Revision Description	Date	Rev. No.	Issued by
LRD Amendment Application	09-10-2026	A3-C01	MM

Project: Player Wills
Location: Former Player Wills Site, South Circular Road, Dublin 8
Client: CWTC Multi Family ICAV

Drawing Title: PW2 - Proposed Level 08 Plan
Drawing No.: 25068-OMP-PW2-08-DR-A-1008

PW2 - Proposed Level 08 Plan

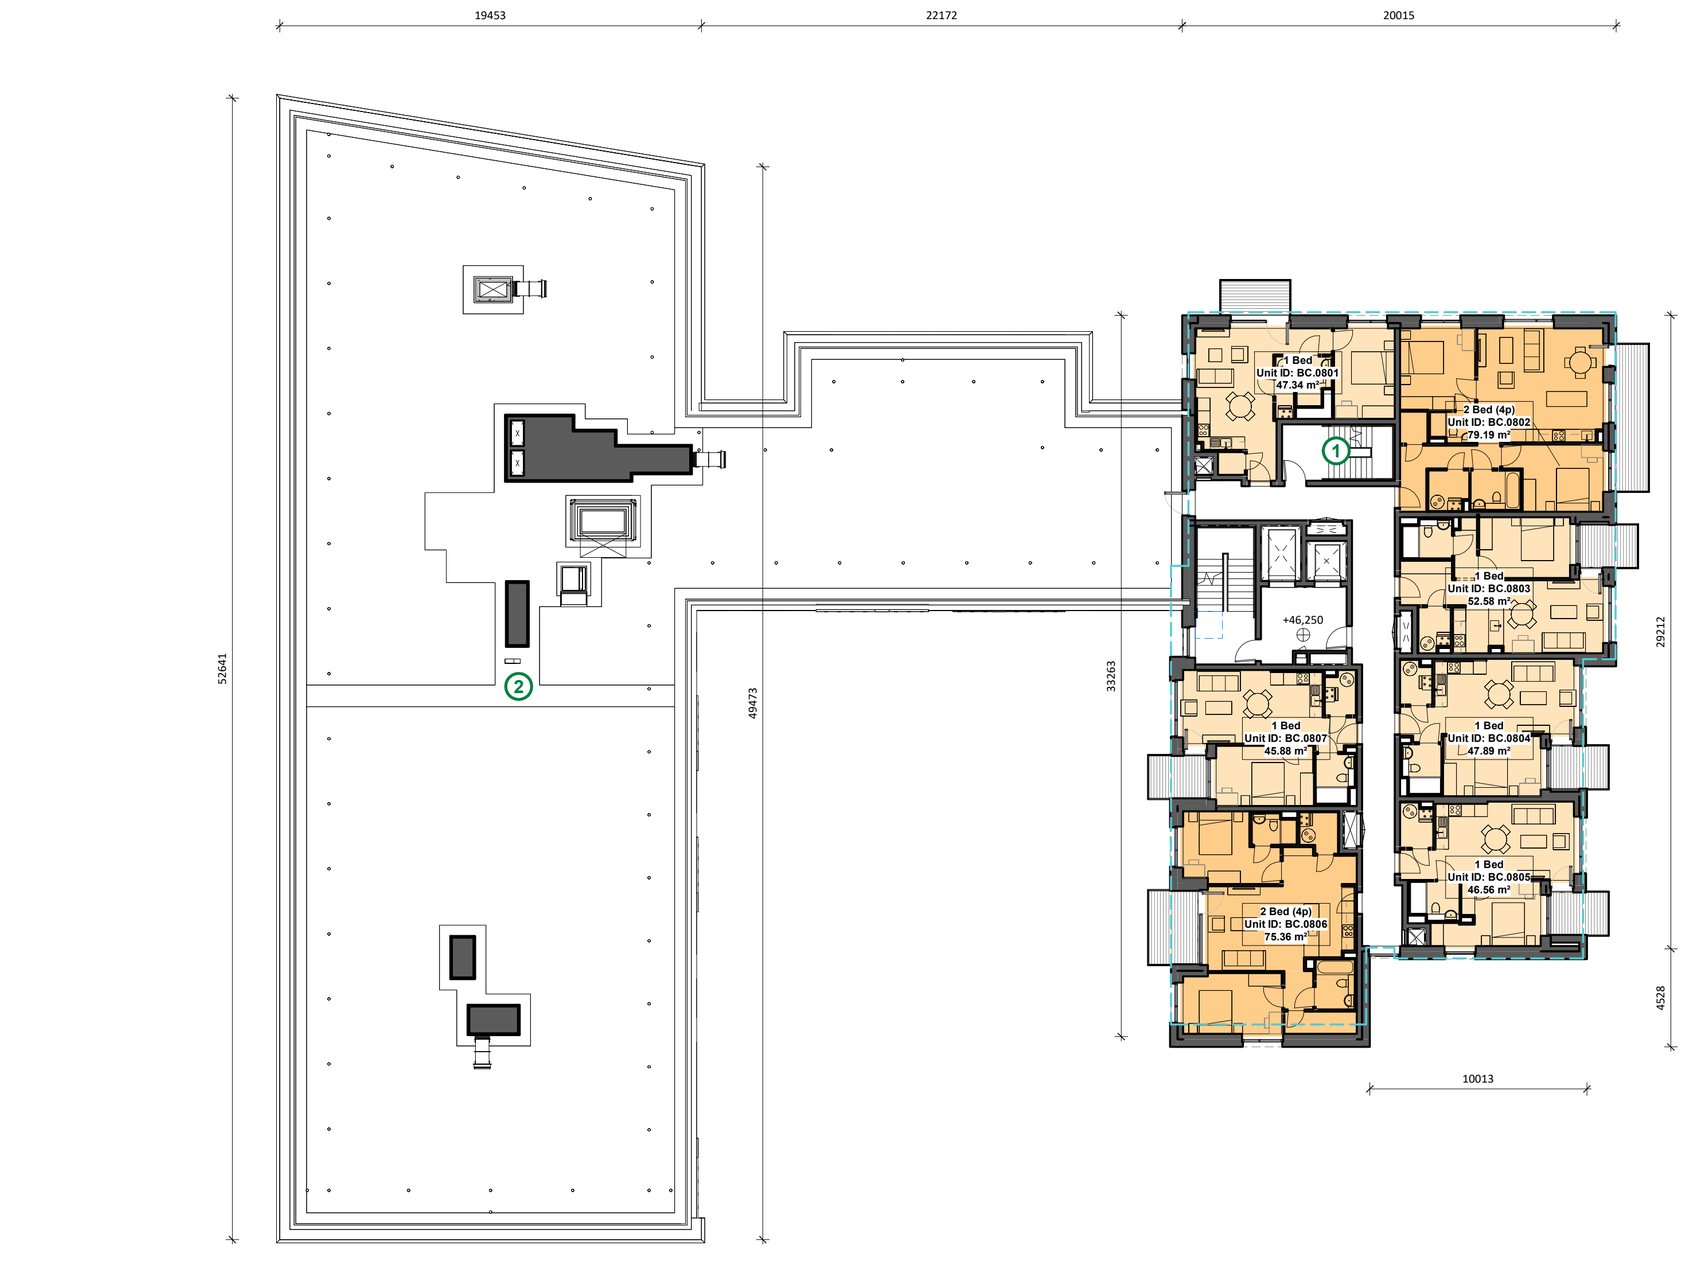
1. Provision of a second stair in accordance with updated Building Regulations (TGD Part B), with associated reconfiguration of layouts.
2. Removal of roof level plant screen
